# GS-15009

## General Supplemental Specifications for Highway and Bridge Construction

**Effective Date**  
**October 15, 2019**

**Figure 4137.01-01: AASHTO T 350 Test Temperature by County (°C)**

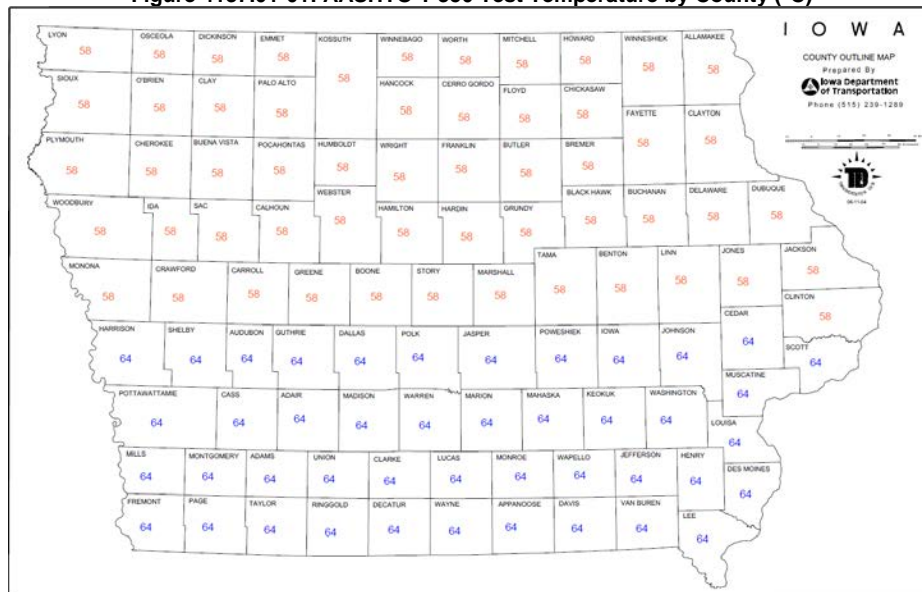
(Delete figure)
